# Access Compliance Report

## Public Rights-of-Way

Intersection ID: 30559	Main Street: FALLING_MEADOWS_LN	Cross Street: GREENCREEK_DR	Location: E
ADA ID: 8D349A72DF7E	Ramp Type: PerpDiag	Initial Pass/Fail: Fail	Overall Compliance: No
Severity Score: 12.5			
Codes/Mitigation Info/Possible Solution		Field Measurements/Component Compliance

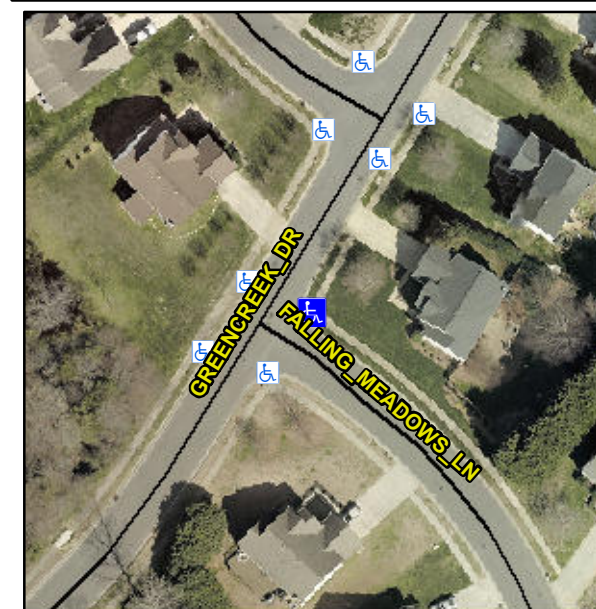
**R304.2.2**

Compliance	Description	Data	Compliance	Description	Data
N/A	Ramp Length (in)	44.0	No	Ramp Slope (%)	8.6
Yes	Ramp Width (in)	48.0	Yes	Ramp XSlope (%)	0.1
N/A	Flare Type LT	N/A	N/A	Flare Type RT	N/A
N/A	Flare Slope LT (%)	N/A	N/A	Flare Slope RT (%)	N/A
N/A	Flare Traversable LT?	N/A	N/A	Flare Traversable RT?	N/A
N/A	Landing Length (in)	N/A	N/A	DWS Provided?	N/A
N/A	Landing Width (in)	N/A	N/A	DWS Contrast?	N/A
N/A	Landing Slope (%)	N/A	N/A	DWS Length (in)	N/A
N/A	Landing X Slope (%)	N/A	N/A	DWS Full Width?	N/A
N/A	Landing Curb? (Y/N)	N/A	N/A	DWS Offset (in)	N/A
N/A	Shared Landing?	N/A			
N/A	Gutter Ponding?	N/A	N/A	Gutter Slope (%)	N/A
N/A	Gutter Lip Ht (in)	N/A	N/A	Gutter X Slope (%)	N/A
N/A	Painted X Walk1?	No	N/A	Painted X Walk2?	No
	X Walk 1 Direction	To NW		X Walk 2 Direction	To SW
N/A	X Walk 1 Width (in)	N/A	N/A	X Walk 2 Width (in)	N/A
	X Walk 1 Slope (%)	1.2		X Walk 2 Slope (%)	0.6
	X Walk 1 X Slope (%)	1.4		X Walk 2 X Slope (%)	0.7

**Remove & Replace Curb Ramp With Two New Directional Ramps or Equivalent.**
